HOLLEY BRANCH SUBDIVISION, RESUBDIVISION OF LOTS 32 & 33

APPLICATION NUMBER 1 DATE March 3, 2011

REQUEST _____ Subdivision _____

DETAIL SITE PLAN

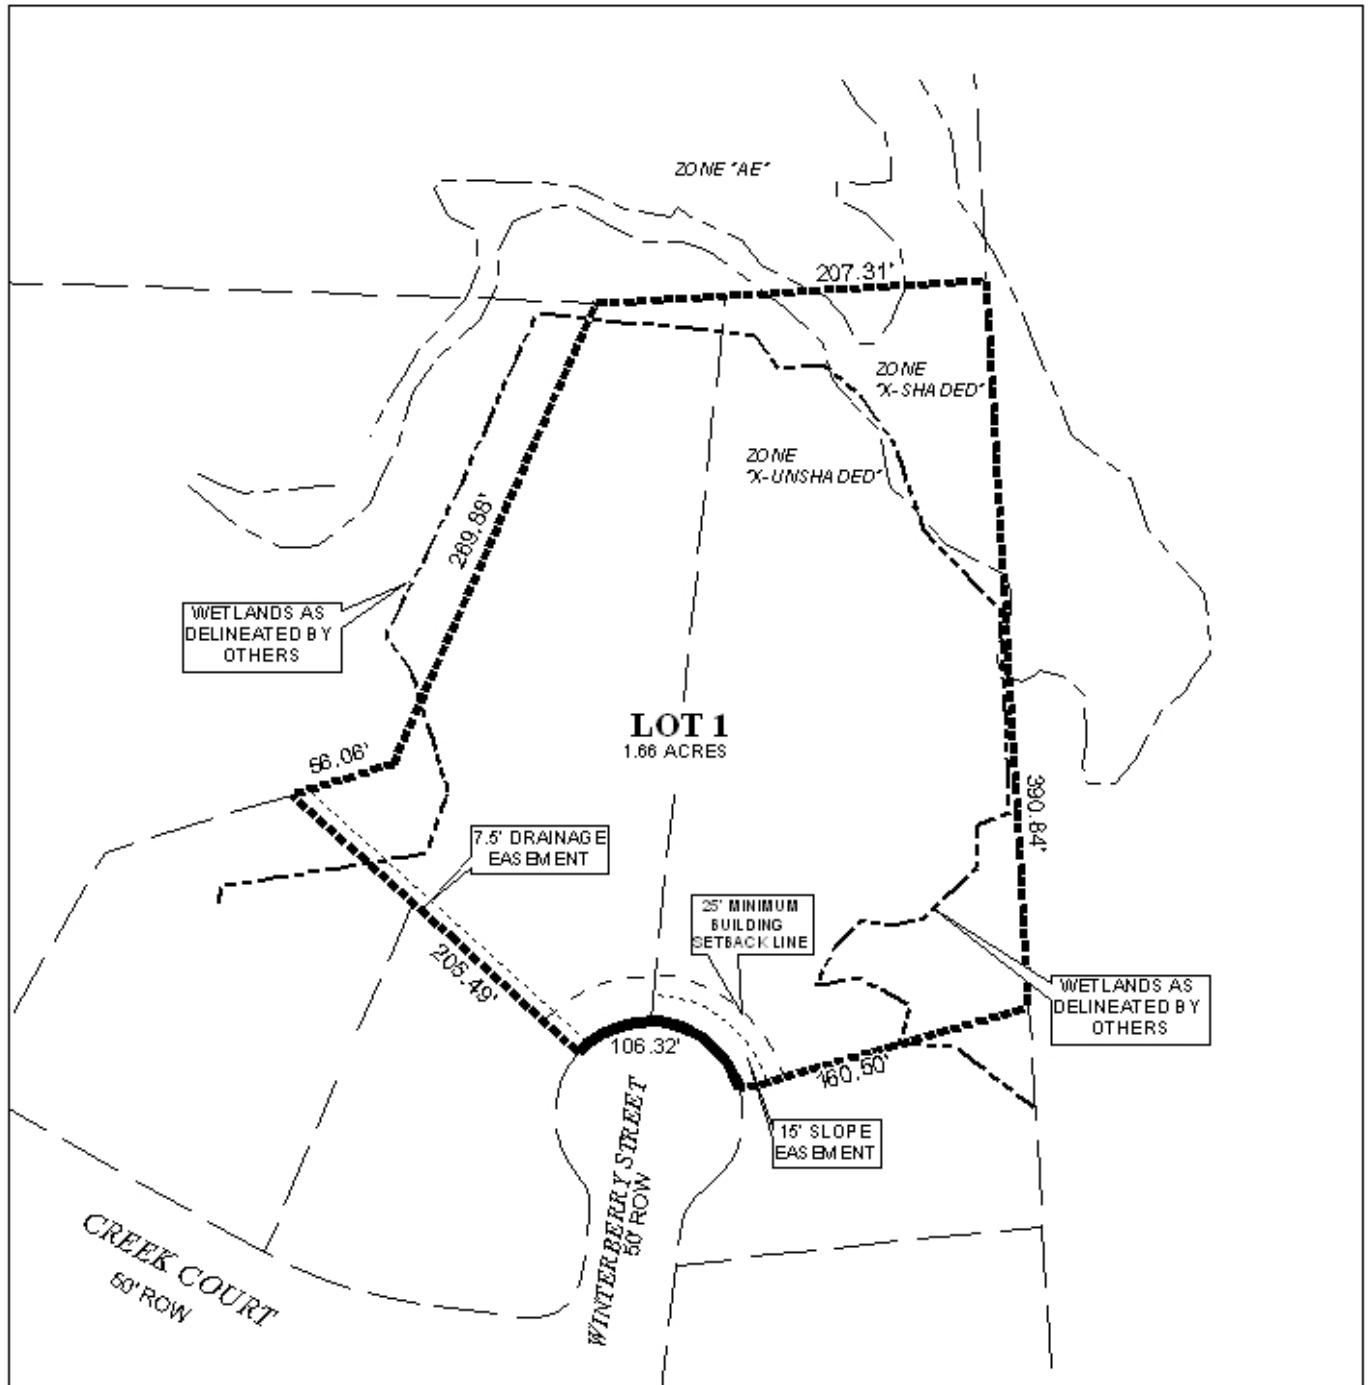
The 25-foot minimum building setback is shown and labeled on the preliminary plat, and should be retained on the Final Plat.

The lot sizes are labeled on the preliminary plat with the sizes in square feet and acres, however the acres given are incorrect, and should be corrected on the Final Plat, if approved. The lot size seems to be larger than most of the currently existing lots in the Holley Branch subdivision, most of which are less than 1 acre with the exception of one lot that is 3.74± acres in size, and the two lots that are proposed to be combined.

- 1) depiction of the 25-foot minimum building setback line from all public right-of-ways, as required by Section V.D.9. of the Subdivision Regulations;

- 2) correction of the label of the size of the proposed lot on the Final Plat;
- 3) the labeling of each lot with its size in square feet, or placement of a table on the plat with the same information;
